**Private Plan Change 69:
Rolleston Industrial
Developments Ltd**

Transportation Hearing
Report

SUMMARY OF MY PEER REVIEW

Selwyn District Council (Council) has requested Flow Transportation Specialists (Flow) to review the transportation matters associated with Private Plan Change 69 (PPC69), which has been lodged by Rolleston Industrial Developments Ltd.

Figure 3: ODP movement and connectivity plan

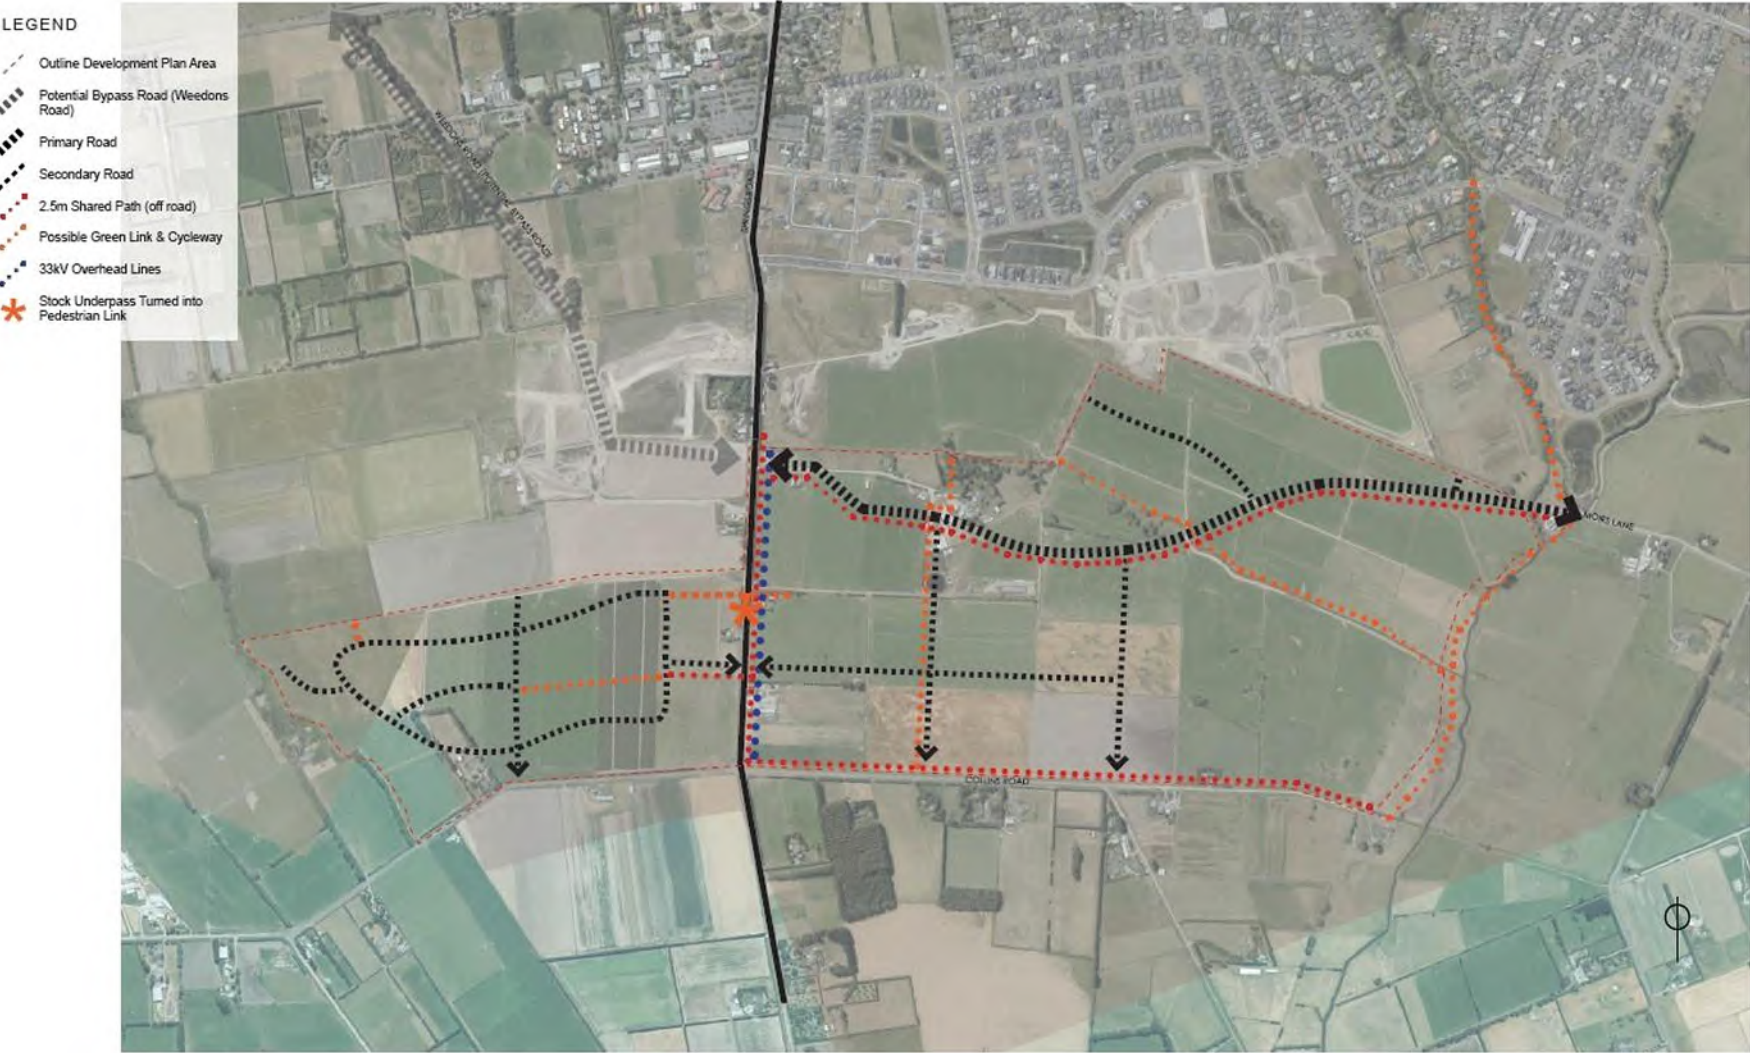
The Movement and Connectivity Plan included in the ODP, shown in Figure 3, includes “Weedons Road Potential Bypass Road”, shown outside of the boundaries of PPC69. Paragraph 27 of the ITA also notes that PPC69 provides for the proposed Lincoln bypass through PPC69.

Figure 9: ODP “Movement and Connectivity” in context with adjacent subdivisions

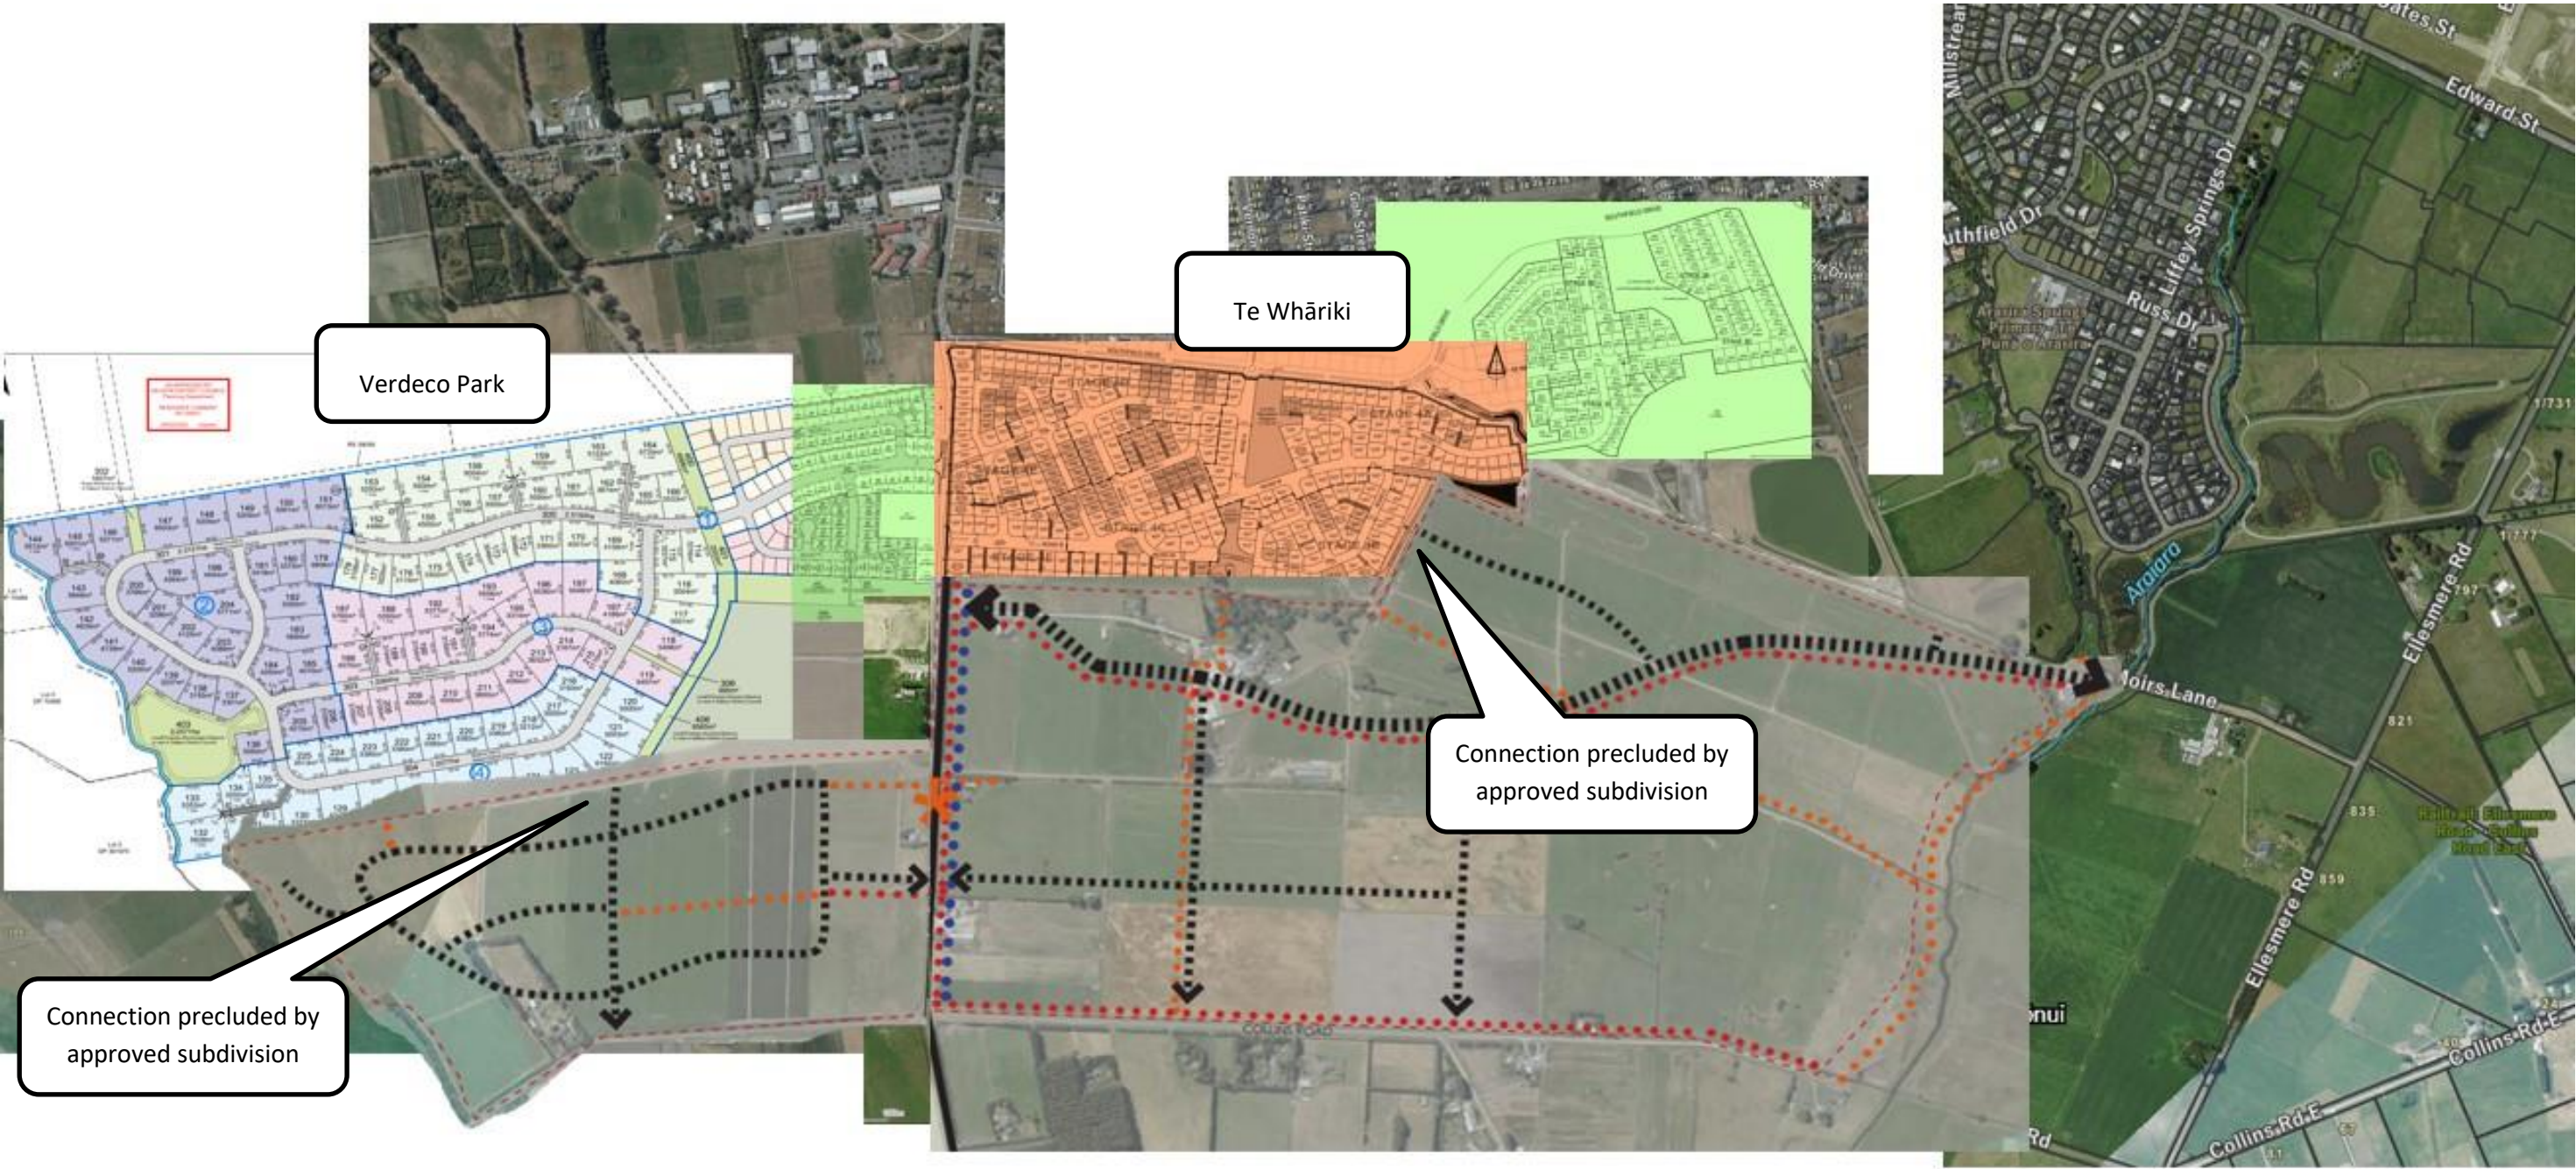
- ♦ Some submitters have raised concerns with the potential link to Liffey Springs Drive, which I discuss further in Section 8. I note that the potential connection to Liffey Springs Drive is outside the scope of PPC69, and that the ODP only seeks to future proof for this connection rather than deliver it. If this connection was formed it would likely need to be led by Council, and the 2031 Paramics model indicates that it would result in around 200 additional vehicles per hour on Liffey Springs Road during the AM and PM peaks. I understand that Council is not planning to form this connection
- ♦ Roding connections to Verdecos Park have been precluded by consented subdivision
- ♦ Roding connections to Te Whāriki have been precluded by consented subdivision.

Outcome: The potential future roading connections to Verdecos Park and Te Whāriki subdivisions, shown in the ODP, have been precluded by consented subdivisions. The potential future roading connection to Liffey Springs Road is feasible, however would require an alignment through a Council reserve and not proposed by PPC69. I consider that PPC69 will not be well connected to surrounding urban developments and will primarily rely on Springs Road and Ellesmere Road to connect with the existing Lincoln urban area. As a result, I consider that PPC69 will have poor connectivity to adjoining urban areas, and lower active and public transport usage.

Figure 10: Recommended amendments to the ODP

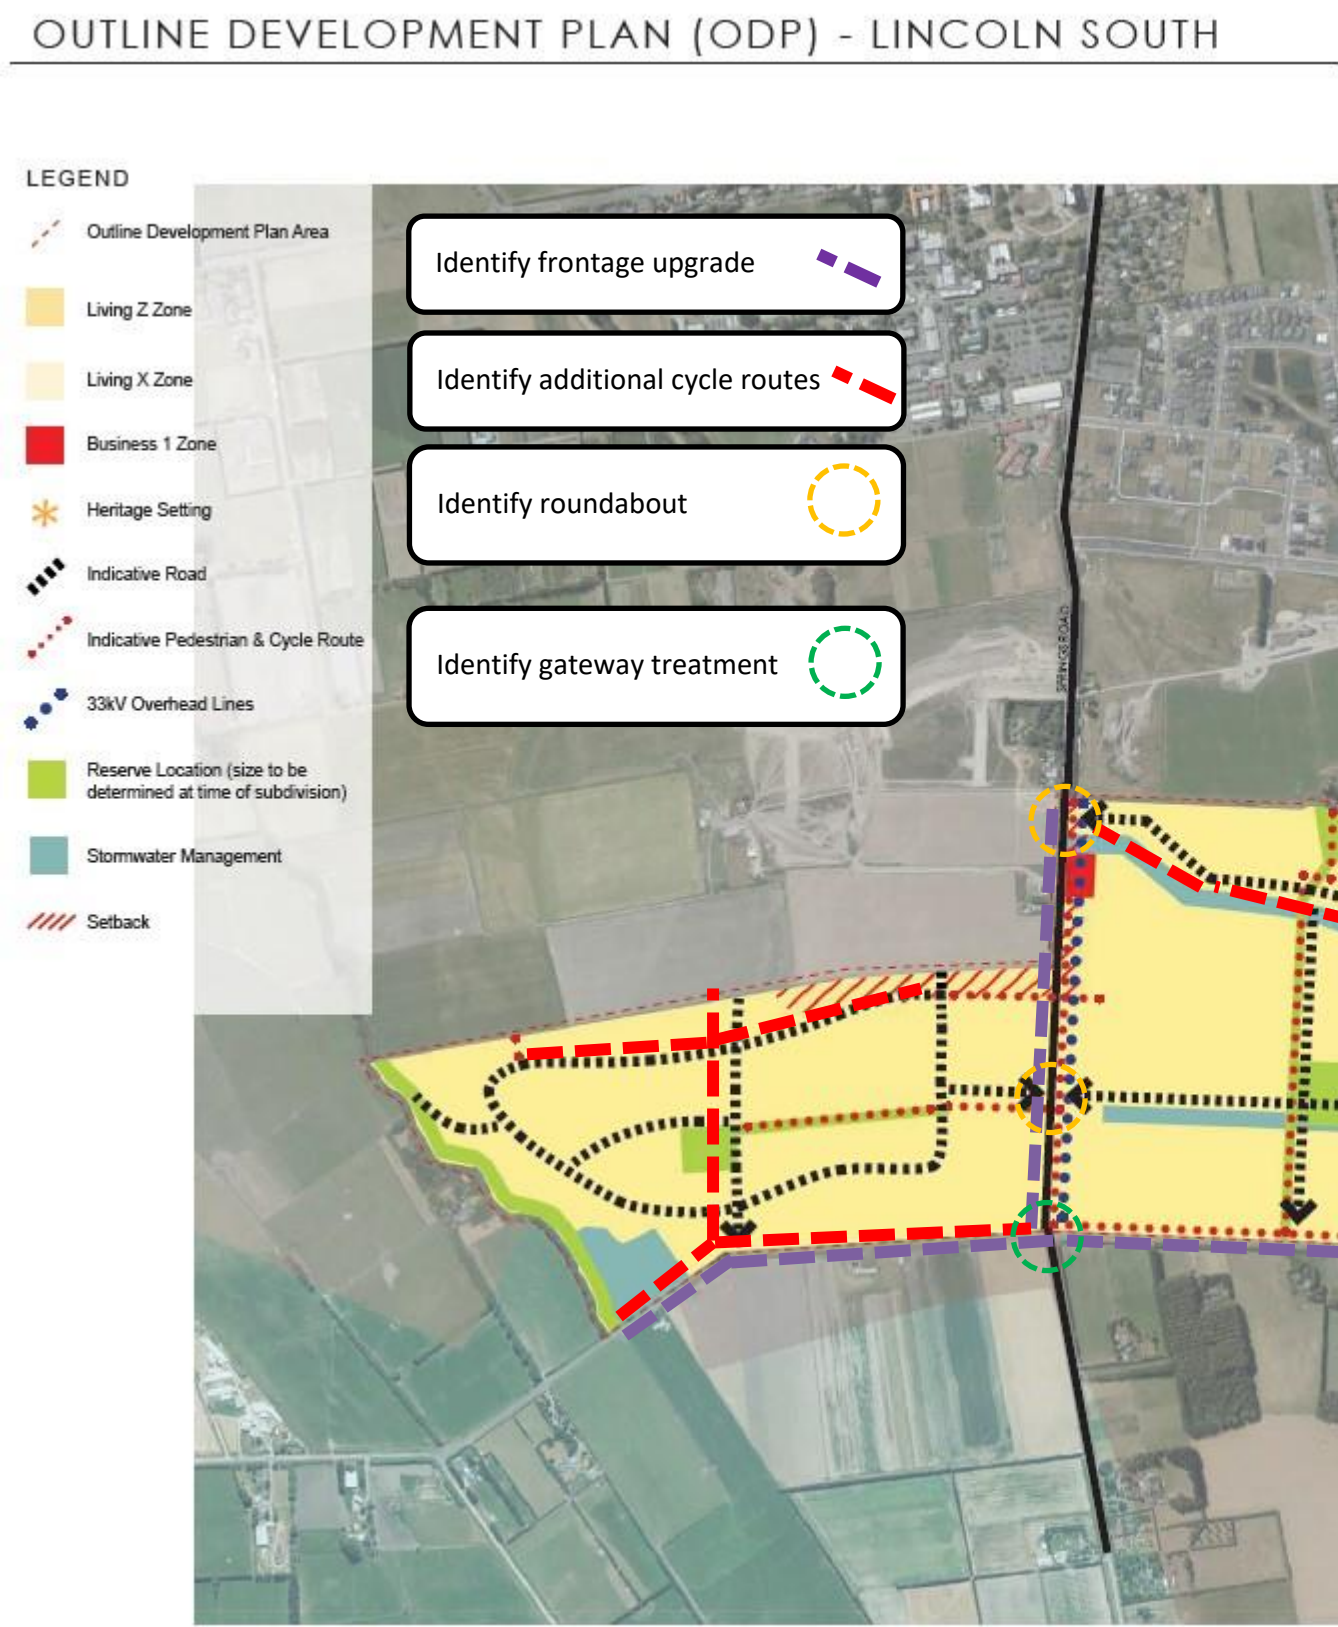
I support the ITA’s recommendation for roundabouts at these intersections as this supports safer traffic movements and better opportunities for safe pedestrian and cycle crossing points. I recommend that this is identified on the ODP, refer to my recommended amendments in Figure 10.

I recommend that the ODP should indicate that these upgrades are required to be delivered by the developer, and I have suggested amendments to the OPD in Figure 10.

I support these links and recommend that additional walking and cycling links are included within PPC69 to ensure a continuous network and enable greater uptake of walking and cycling. I have suggested amendments to the OPD in Figure 10.

Outcome: I recommend that the ODP should be amended to include additional walking and cycling routes within PPC69.

Figure 11: Lincoln Structure Plan with PPC69 location

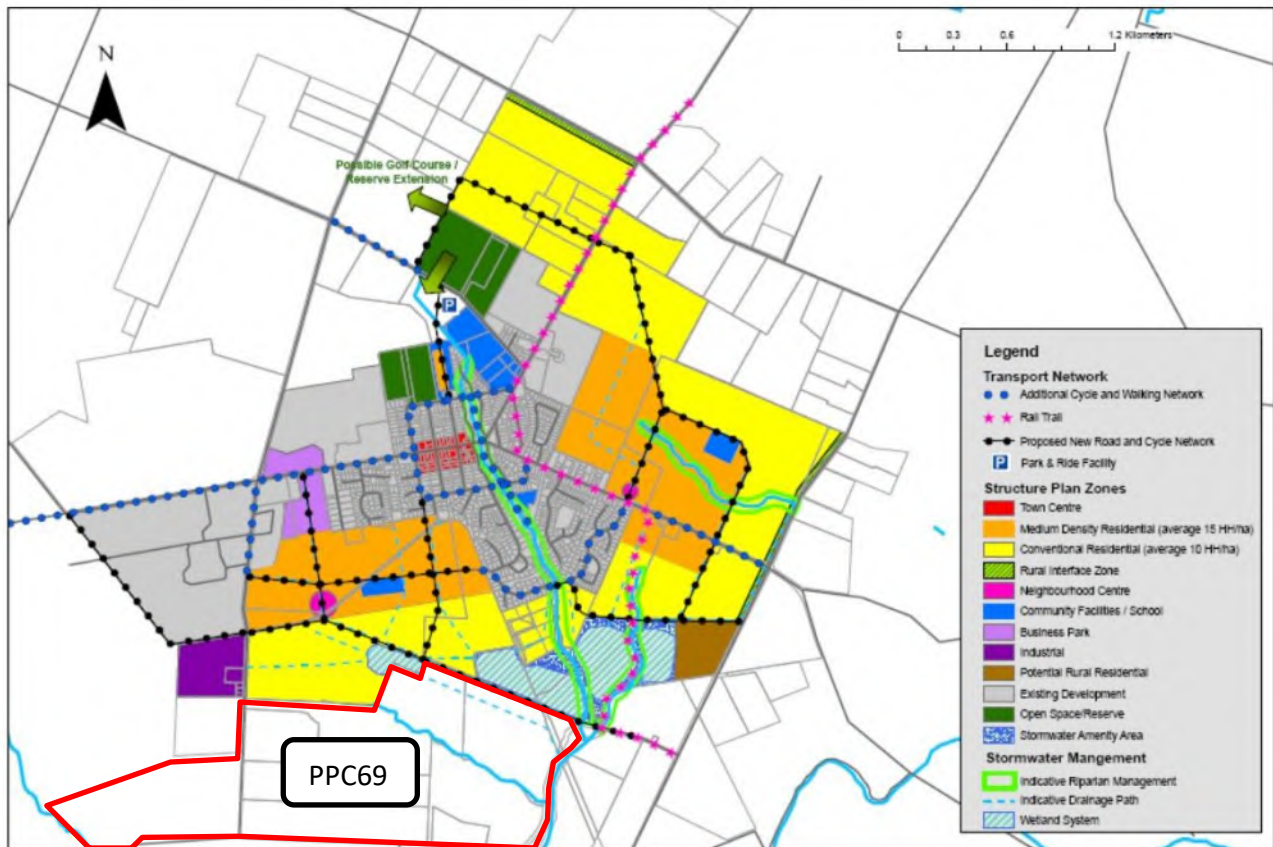
PPC69 sits outside the anticipated urban area of the Structure Plan, as shown in Figure 11, as well as the proposed infrastructure boundary specified in the Canterbury Regional Policy Statement (CRPS) Map A⁶.

Outcome: PPC69 is inconsistent with the Lincoln Structure Plan, in that it is outside the anticipated urban area. Should PPC69 affect the quantum of residential growth within Selwyn, without a corresponding increase in local employment and access to services, additional impact on the Greater Christchurch transport network can be expected as additional residents in Selwyn travel to access services and employment. However, assessing the effects of such development on the long term planning and funding commitments associated with bulk transport infrastructure is complex and requires assessment of multiple land use scenarios.
